ARMY EQUIPMENT
SUPPORT PUBLICATION

TRUCK 4T, 4 x 4 BEDFORD MJP

SPECIAL ENVIRONMENT INSTRUCTIONS
WATERPROOFING INSTRUCTION NO.1

Fig 1. Modified oil drain pipe, upper turbocharger

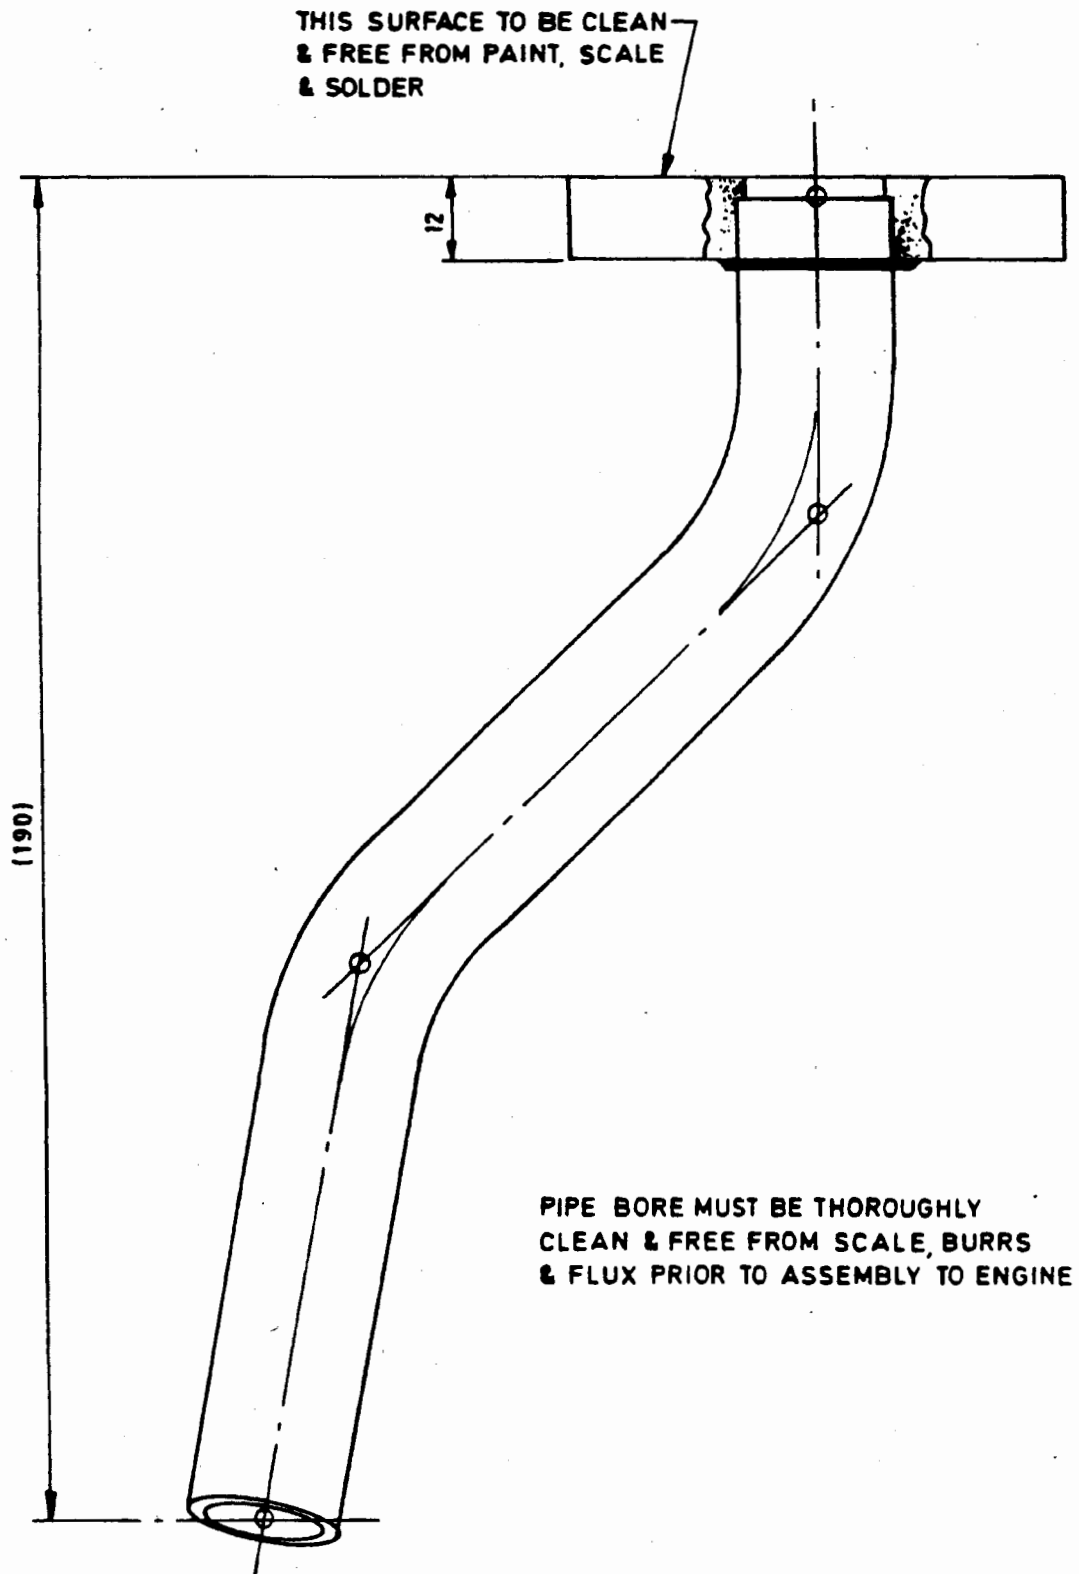
7.1 When issued with oil drain pipe assy c/w 12mm thick flange (item 1), remove and discard early pattern drain pipe assy c/w 8mm thick flange (item 4) and its 22mm lg securing screws (item 5). Retain any washers.

7.2 Remove old gasket and clean mating face and surrounding areas of turbocharger.

7.4 Remove 55mm lg bolts (item 6) retaining the oil feed adaptor housing to the turbocharger and install and tighten 58mm lg bolts (item 3) to between 12 and 16 Nm.

Fig 1 Tachometer Earthing

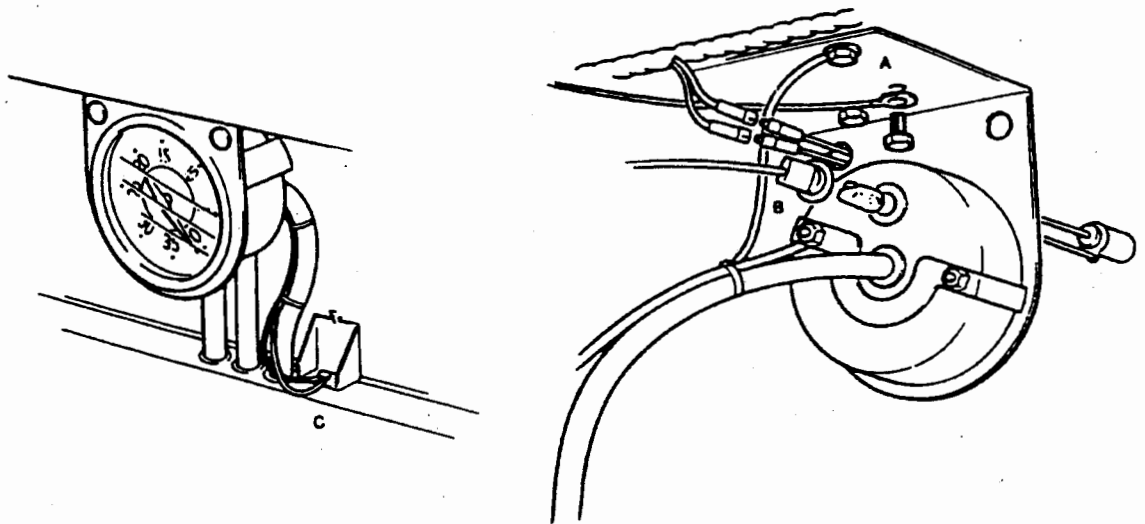
1 It has been found necessary to fit earthing leads to the tachometer and mounting bracket to prevent radio interference. This instruction gives the necessary detail.

3.1 Remove the bolt at position A, clean the area and the bolt, fit one earthing lead and refit the bolt.

3.2 Remove the tachometer mounting nut at position B, clean the area and fit a second earthing lead, refit the nut.

3.3 Remove the bolt on cab bracket at position C, clean the area and bolt, secure both earthing leads and refit the bolt.
